**SERVICE BULLETIN**

**APPLICABILITY:** 2013MY BRZ

**NUMBER:** 09-54-12

**SUBJECT:** High-Pitched "Chirp", "Squeak" or "Cricket" Sound from the Engine

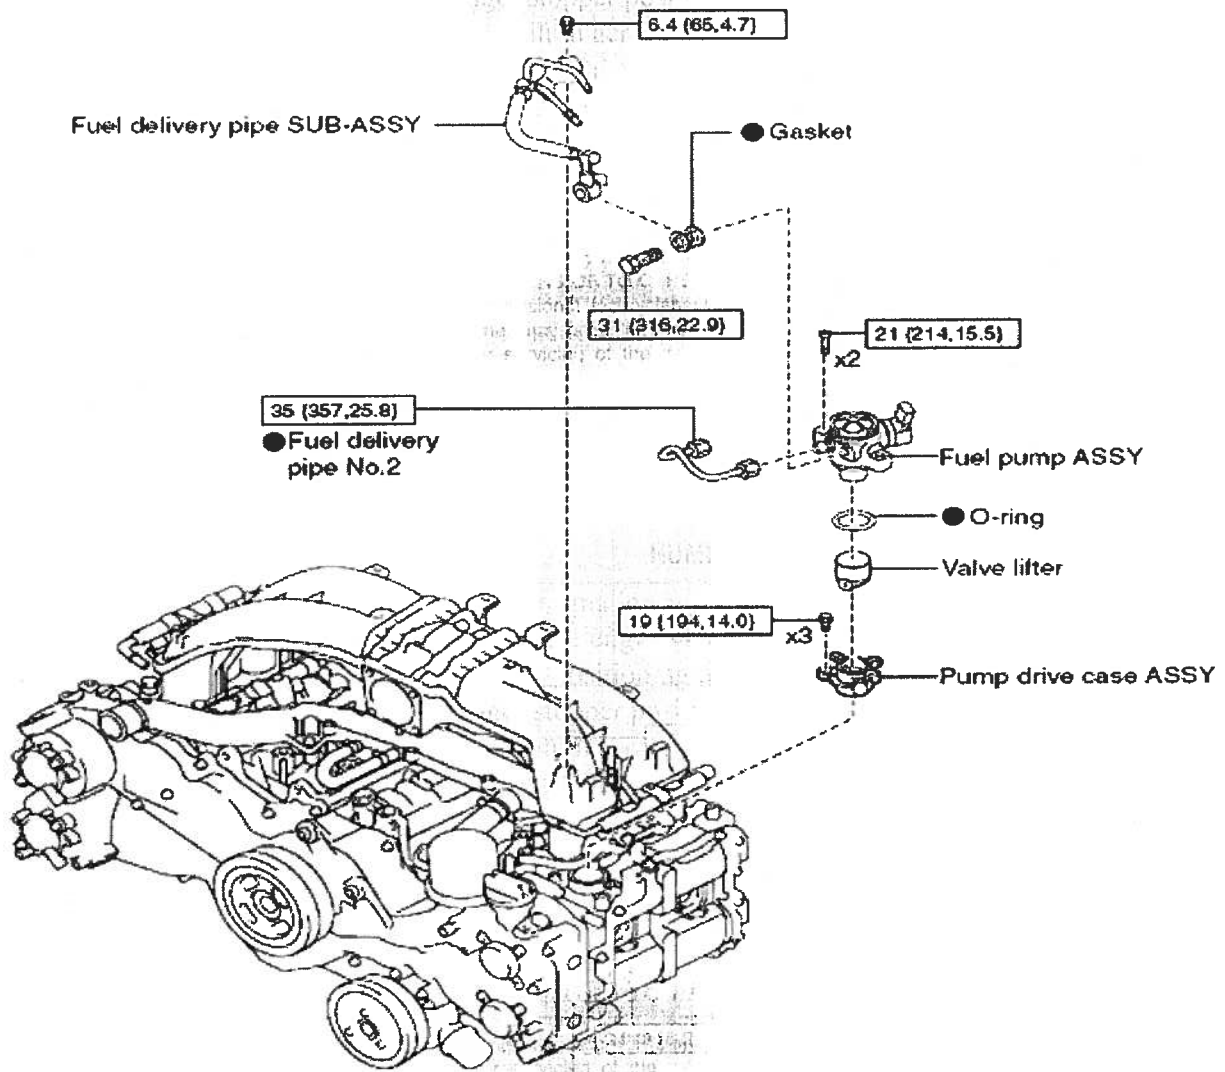
The purpose of this bulletin is to provide information regarding a high-pitched "chirp", "squeak" or "cricket" sound you may hear coming from the engine's high-pressure fuel pump. **Not all pumps may exhibit this sound.** It is a result of the positioning of the plunger stopper inside the high-pressure pump. Some may have a plunger stopper position that when combined with certain fuel temperatures or fuel formulations, may result in aeration of the fuel within the body of the pump causing this sound when the engine is idling. **This result is non-detrimental to the fuel system or engine.** Not all pumps will exhibit this condition. A production change was made to consistently orient the position of the plunger stopper during assembly thus eliminating the source of the sound. Once the chirping sound has been confirmed, the high-pressure pump assembly must be replaced to remedy the condition.

- Items indicated in the exploded view with a ● are “non-reusable” and **MUST** be replaced.
- The o-ring is included with the fuel pump assembly.
- Part numbers and quantity required to complete the procedure are listed below.

**IMPORTANT:** Always follow the tightening torque specifications as indicated in the applicable Service Manual (and the exploded view diagram on pg. 2) during re-assembly.
